Standards Update Transmittal

Reference Number: 2021-06
Standards: Improvement Standards, Section 5-8.B, 5-8.H
Construction Specifications, Section 49
Standard Drawings, SL-3, SL-7, SL-8, SL-9, SL-10, SL-11, SL-20,
SL-22, SL-30, SL-31, SL-40, SL-42, SL-46

DRAWING NUMBER
SL - 7

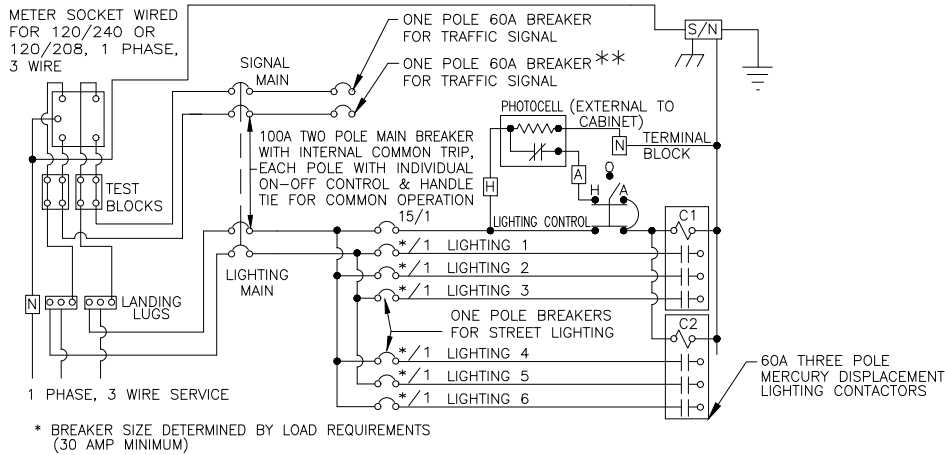
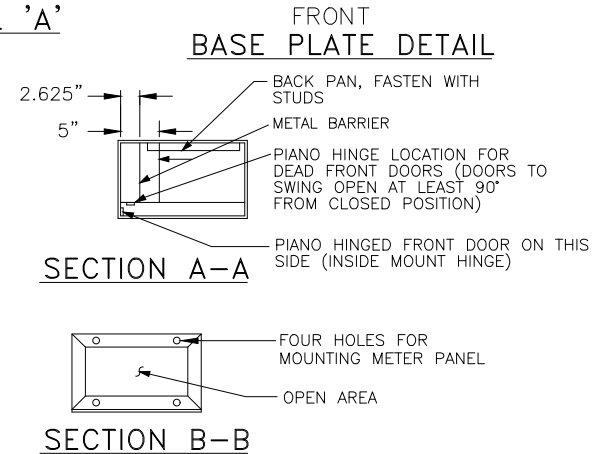
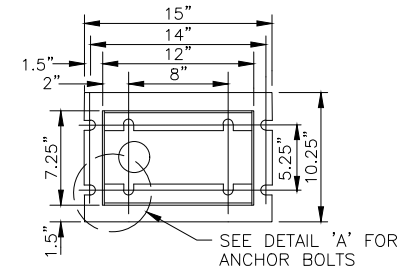
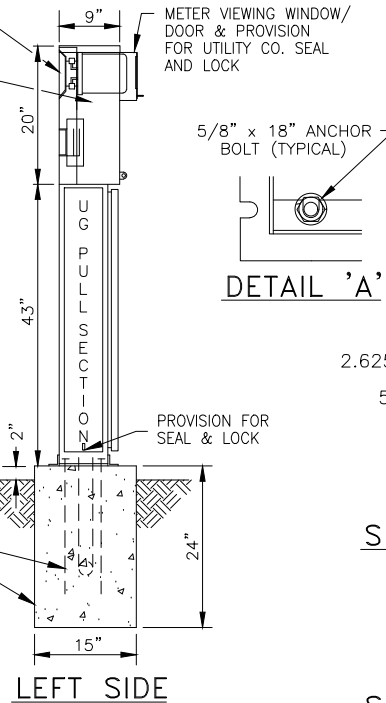
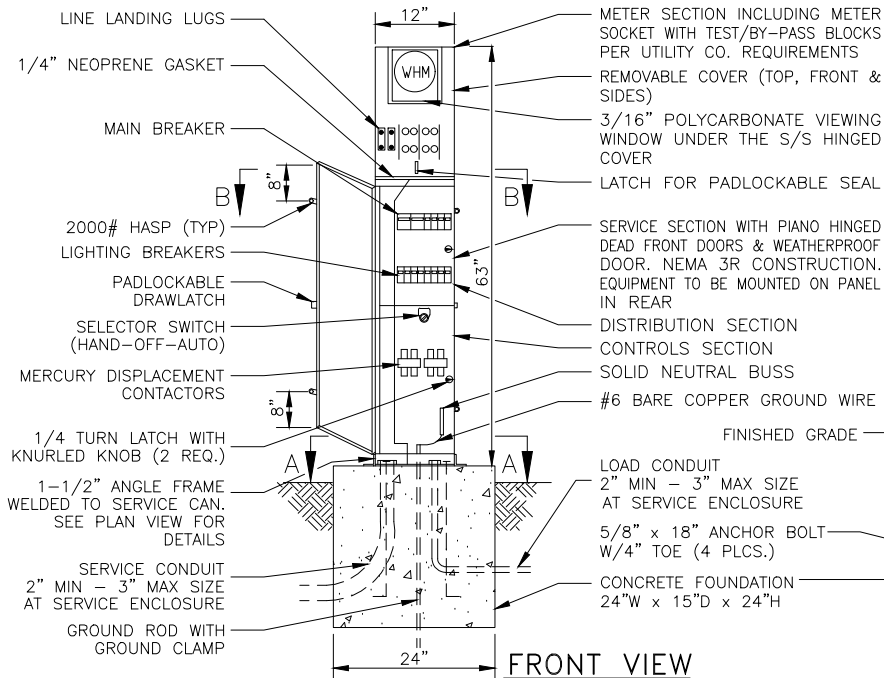
- c. SL-7, SL-8 and SL-9: Add note "Street light circuits shall have a dedicated service meter and shall not be wired to bypass the meter."
 - d. SL-10 and SL-11: Delete drawings (City and SMUD no longer allow metered service)

- SEE STANDARD SPECIFICATIONS FOR ADDITIONAL DETAILS.
- DUAL METERS SHALL BE PROVIDED AND SHALL CONFORM TO CALTRANS STANDARD DRAWING ES-2F.
- STREET LIGHT CIRCUITS SHALL HAVE A DEDICATED SERVICE METER AND SHALL NOT BE WIRED TO BYPASS THE METER.

DRAWING NUMBER
SL - 20

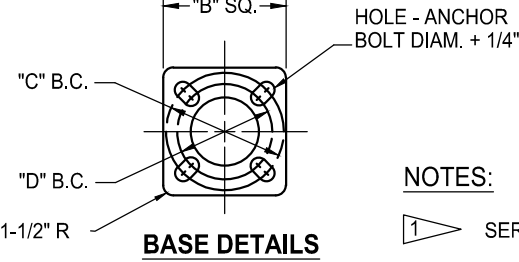
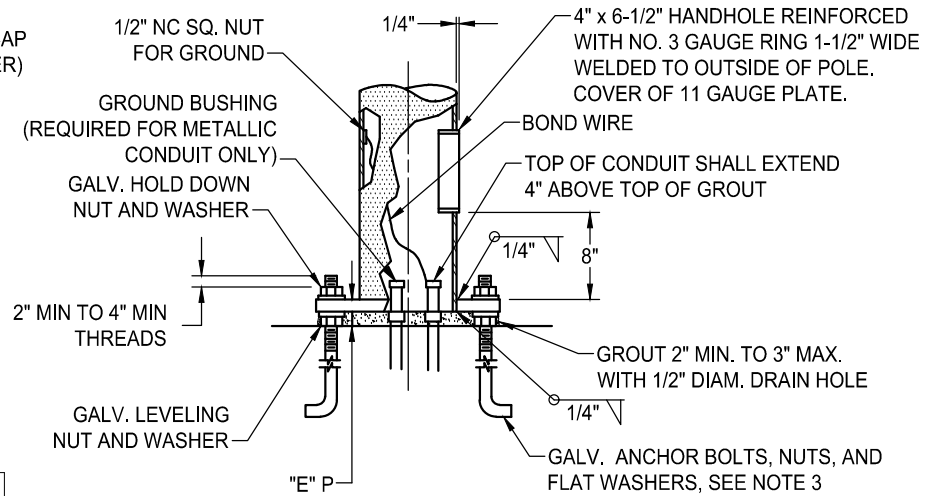
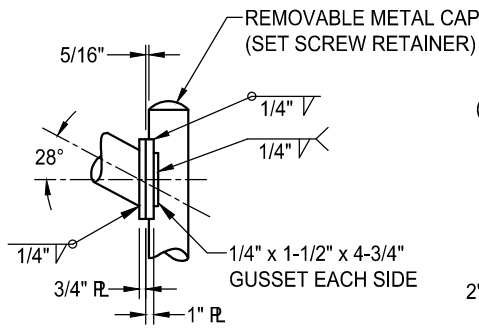
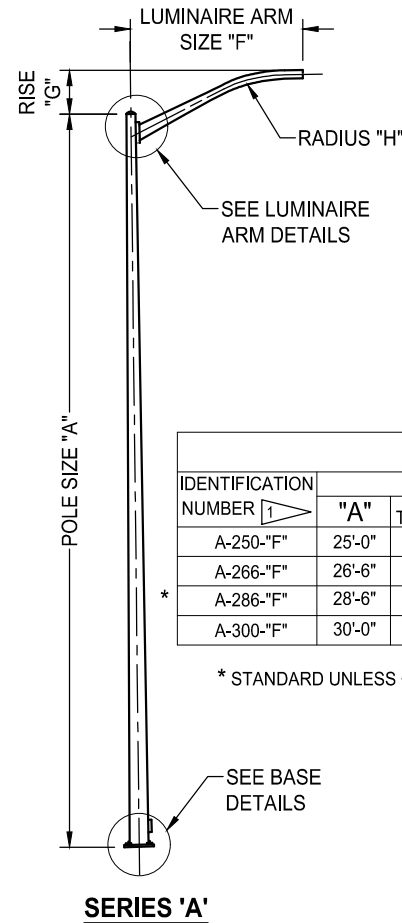
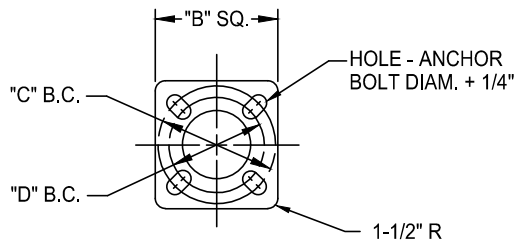
- e. SL-20, SL-22, SL-30, SL-31, SL-40, SL-42, AND SL-46: Remove reference to specific anchor bolt sizes and specify that anchor bolts shall conform to pole manufacturer's design requirements, which shall be in accordance with AASHTO "Standard Specifications for Structural Supports for Highway Signs, Luminaires, and Traffic Signals." Additionally on SL-20 update Pole A Series GA from 10 to 11 gauge.

- SERIES 'A' NUMBERING PROCEDURE
 POLE SIZE 'A' → A-286-8 → LUMINAIRE ARM SIZE 'F'
 (STANDARD UNLESS OTHERWISE SPECIFIED)
- STANDARD SHALL BE INSTALLED SO HANDHOLE FACES THE STREET.
- ANCHOR BOLT SIZES SHALL BE PURSUANT TO THE POLE MANUFACTURER'S DESIGN REQUIREMENTS, WHICH SHALL BE IN ACCORDANCE WITH AASHTO "STANDARD SPECIFICATIONS FOR STRUCTURAL SUPPORTS FOR HIGHWAY SIGNS, LUMINAIRES, AND TRAFFIC SIGNALS."
